REGULAR MEETING AGENDA

D. Public Hearing - Delta Riverwalk Planned Unit Development (PUD) Sketch Plan

To: City of Delta Planning Commission
 From: Joe Gillman, Community Development Manager; Mike Markus, City Planner; and Raini Ott, Contract City Planner
 Date: December 4, 2023
 Subject: Delta Riverwalk Planned Unit Development (PUD) Sketch Plan

Delta Riverwalk PUD - Sketch Plan
519 & 595 State Highway 92, Delta, CO
November 7, 2023

Figure 3: Cross Section of Proposed Local Street Design

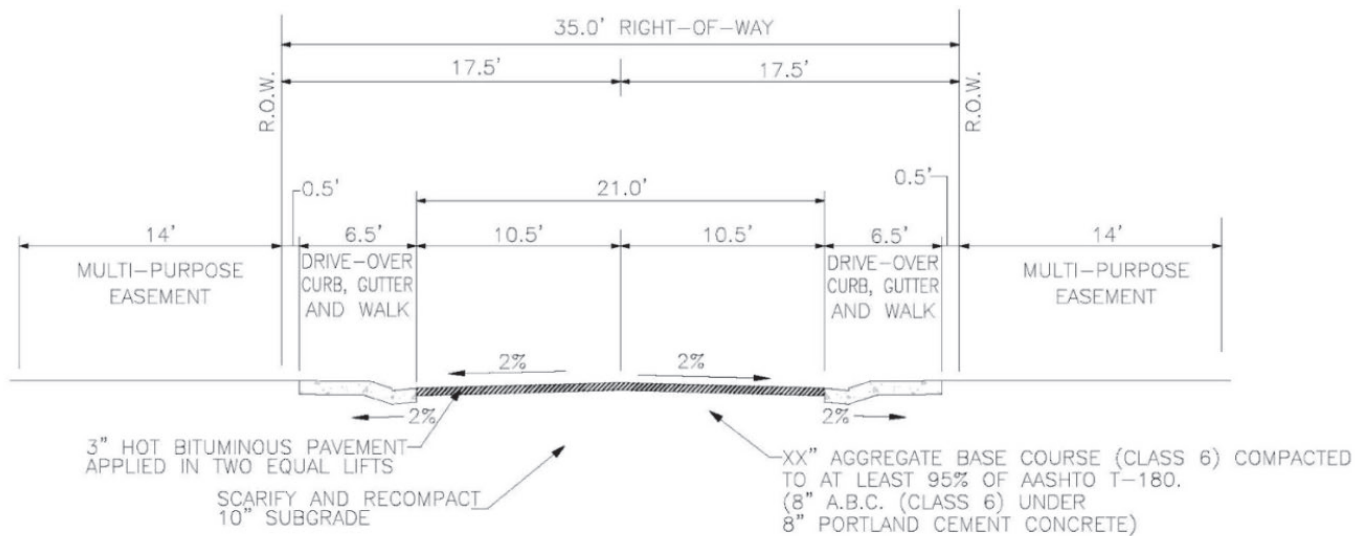
Per Section 16.05.050, PUDs must conform to the minimum subdivision design standards as set forth in Section 16.04.070; although, the City may consider and approve deviations at its discretion if criteria described under subsection (B) is met. Section 16.04.070(C)(13) states that the minimum dedicated right-of-way width for a Local Street is 50 feet, and the pavement width required between face of curbs is 38 feet. Sidewalks along a Local Street must also be provided at a minimum width of five feet from back of curb and may be combined with curb and gutter (i.e., drive-over or rolled curb) except where safety concerns require that vertical curb be used, per subsection (D). As proposed by the Applicant, this PUD would use a street design with reduced right-of-way and pavement widths of 35 feet and 21 feet, respectively (Figure 3) (Attachment A, page 6). With the lesser street widths proposed, emergency vehicle clearance as well as trash pick-up, deliveries, and other curbside services cannot adequately be provided without a complete and enforceable prohibition of on-street parking.

As part of the Applicant’s argument for this deviation, they pointed to recent developments in other jurisdictions, including the City of Grand Junction, where these reduced widths were approved and implemented; however, no specific details about those approvals or the conditions under which they were granted have yet been provided. Grand Junction is in the process of updating its Transportation Engineering and Design Standards (TEDS) manual, including a process to allow for alternate street designs, such as the proposed, subject to detailed and specific conditions. On October 10, 2023, the Grand Junction Planning Commission voted to not recommend approval of the updated TEDS manual to the Grand Junction City Council, and on November 15, 2023, the City Council continued consideration of the matter to the meeting scheduled for December 6, 2023.

To fully address staff’s concerns and be approved for a deviation to the standard street width, the Applicant must provide sufficient evidence to demonstrate compliance with the deviation criteria as set forth in Section 16.04.070(B). This includes demonstrating that 1) the deviation will not adversely affect the quality of the subdivision or public health, safety, and welfare, and 2) the alternative design is either necessary to reasonably accommodate development; or will more

effectively implement the purposes of the subdivision regulations; or is superior in functionality, durability, or utility. Primarily, the Applicant must demonstrate how a prohibition of on-street parking will be realistically enforced to maintain a minimum 20-foot clearance for emergency vehicles at all times. Additionally, due to the proposed prohibition of on-street parking, the Applicant must provide for sufficient off-street guest parking throughout the development.

Figure 4: Comparison of Existing and Future Flood Hazard Conditions (Subject Properties Outlined in Pink)

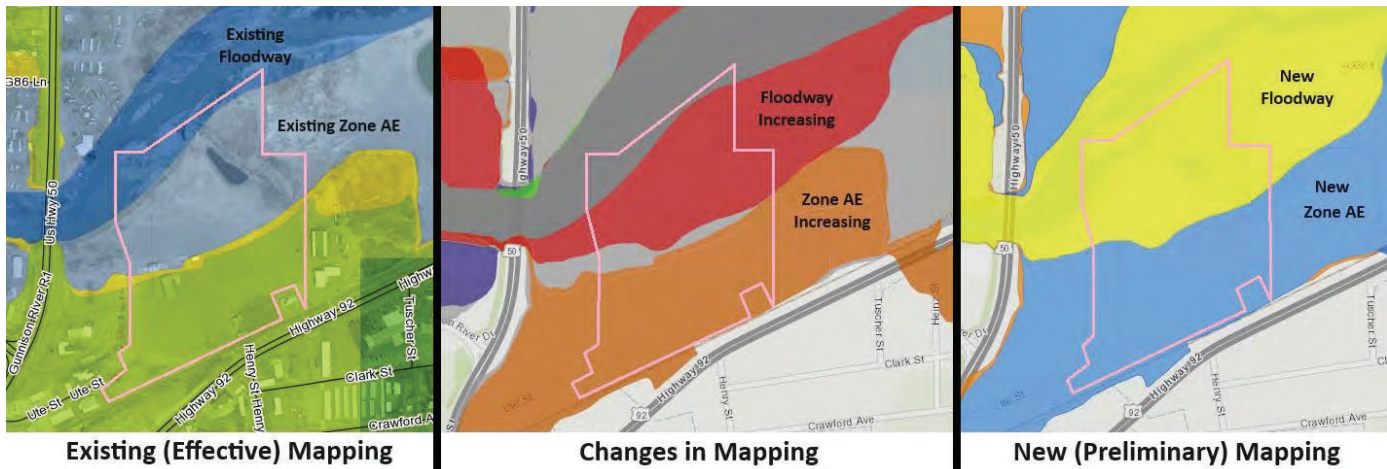
As identified on the Sketch Plan, approximately half of the PUD, including around 75 of the proposed residential lots, is planned to be located within Zone AE of the Special Flood Hazard Area (SFHA) as delineated on the effective FIRM adopted by FEMA. This indicates a 1% annual chance of flooding for a significant portion of the development based on surveys and studies completed prior to 2010. Within Zone AE, all new construction and other alterations, including subdividing land and site grading, must be reviewed and approved in accordance with the City's Flood Damage Prevention regulations ([Chapter 15.56](#)). Among other requirements, the lowest floor of each new residence must be elevated to one foot above the Base Flood Elevation (BFE) of between 4,936 and 4,939 feet as identified on FIRM Panels [0414D](#) and [0602D](#).

The Preliminary and Final Plats for the PUD must depict specific flood elevation data on the plat map and fully address the standards under Section 15.56.250 to ensure the development and infrastructure serving it is reasonably safe from flooding. These would be the minimum requirements for new development under the effective FIRMs. It should be noted, however, that the more recent preliminary flood hazard mapping identifies that a significant portion of the PUD may be located within the Floodway where there is a higher risk of damage during a 1% annual chance flood event due to anticipated floodwater velocities. Consequently, the standards for development in the Floodway are considerably higher and often infeasible (see Section 15.56.220). In addition to the anticipated increases in land area within the Floodway, the new preliminary mapping shows the remaining PUD area within Zone AE, meaning that the entire Delta Riverwalk PUD may one day be within the floodplain and subject to the relevant development and insurance requirements. New mapping is expected to be adopted by FEMA and take effect sometime in 2025. Figure 4 compares the existing and potential future flood hazard conditions.

There are a variety of ways to reduce flood risk and exposure and to overcome regulatory requirements, none of which will be simple or cheap to implement in regard to this proposed PUD. Mitigation measures or explanations of how the PUD might address these concerns have, so far, been limited to an assertion that it can be done with the stormwater detention area as shown on the Sketch Plan (Attachment A, pages 13 and 17).

In summary, staff finds that sufficient evidence has not been submitted to date to demonstrate compliance with criteria (b), (c), or (d), and additional details are needed prior to Sketch Plan approval or at the time of Preliminary Plat to fully address access concerns, appropriately consider all current site conditions and potential hazards, and demonstrate compatibility with the natural and built environments. Therefore, as presented in the application materials, staff finds the minimum Sketch Plan **criteria not fully met**.

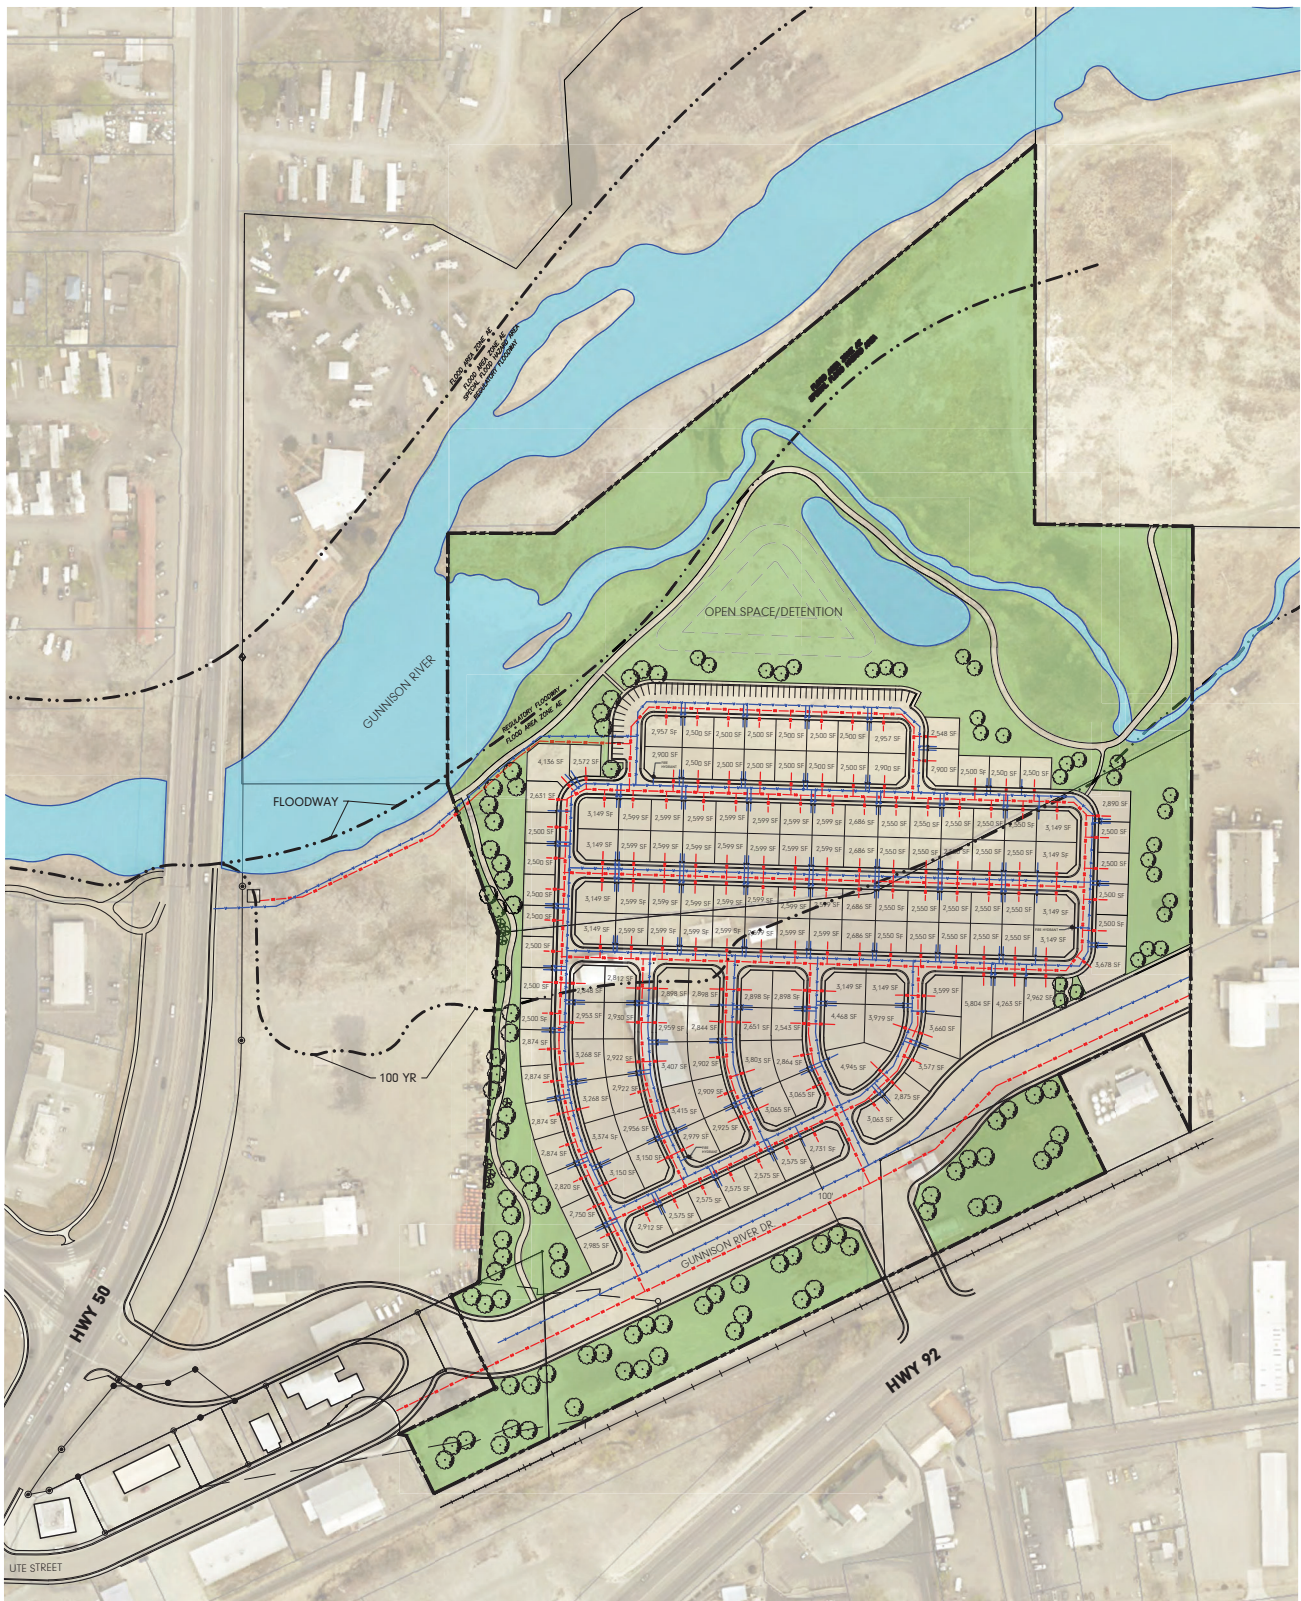
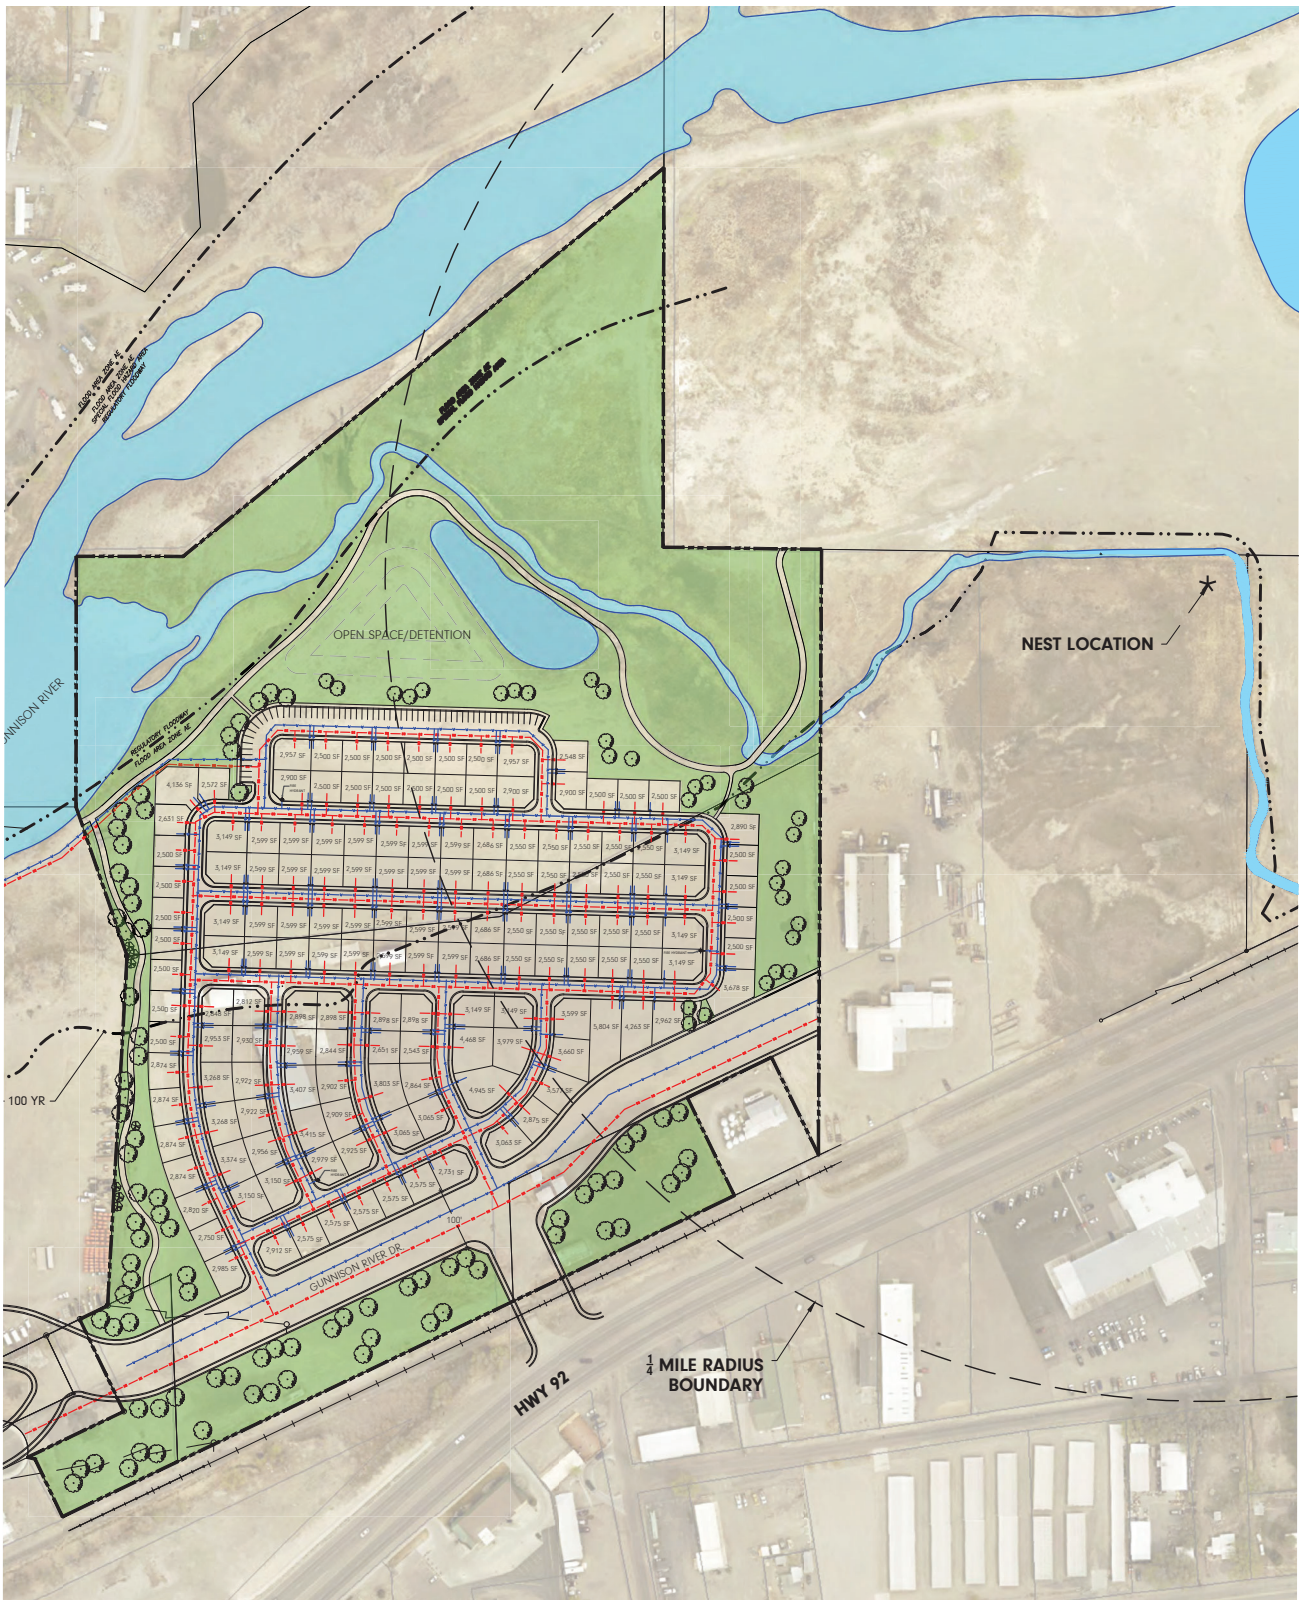
Revisions to traffic circulation are needed to meet Fire Code. Staff suggests making the outer road larger to accommodate higher traffic volumes and function as a secondary ingress/egress. See redlines on plan and additional comments under 16.04.050(C)(4)(a)(iii).

Identify any loading or service areas, especially for proposed nonresidential uses. The development entrance directly off Hwy 92 must be revised so that the tree farm parking area does not back out into the roadway; parking must be accommodated on-site and per the [City Standards and Specifications](#). Additional revisions may be required by CDOT and/or UPRR to conform to the Access Control Plan and avoid traffic conflicts, such as enlarging the entrance, installing a signal, or installing a crossing guard, depending on results of the traffic study. If not signalized, it may be restricted to right-in/right-out. See comments from UPRR regarding application for a new crossing agreement.

At a minimum, the plan must not interfere with future conditions as planned in the [Access Control Plan](#) and [Major Street Plan](#). The future Principal Arterial (100-ft ROW) will be aligned with the existing Gunnison River Dr intersection, but its alignment from there to the east is flexible. Depending on the results of the traffic study for the development, ROW dedication and/or partial construction could be necessary. Further, the access via Ute St may be restricted to right-in/right-out as forecasted in the Access Control Plan. See comments from CDOT and redlines on plan.

Provide an explanation of or demonstrate on the plan how drainage to the proposed detention pond will be accomplished and how flooding will be mitigated, per Section 15.56.250, with this significant increase in impervious surface. Detailed information will be required at Preliminary Plat, including base flood elevation data, grading plan, and drainage system plan.

Identify trash receptacle locations or provide an explanation about how trash will be collected. City trash trucks are side-load, not front-load, so receptacle locations need to be planned accordingly if using city trash services.

Add a vicinity map that identifies the project area, major roadways (e.g., Hwy 50 and Hwy 92), and the river, at a minimum.

Response: The plan has been updated to accommodate the future build out of Gunnison River Dr. and is stubbed to the Doughty property to the east for connection to future development. The 35' ROW has a rollover curb/gutter that allows fire trucks to utilize during an emergency. It's worth considering that the City of Grand Junction Fire Department permits this street template with parking allowed on one side of the street. Signs are used to communicate which side of the street parking is not allowed on.

Response: Civil engineering will begin in earnest during the preliminary plat stage. Detention pond(s) will be sized and designed by a Professional Engineer to accommodate all planned stormwater runoff. Preliminary meetings with Profenssion engineering firms have indicated that the area designated on the sketch plan will be adequate in size to accommodate for needed detention area.

Response: The sketch plan has been updated to show fire hydrants that provide adequate coverage of 400'. Detailed design will occur during the preliminary plat. Trash cans will be placed in the street, consistent with all newer subdivisions that lack alleys.

Response: Vicinity map added
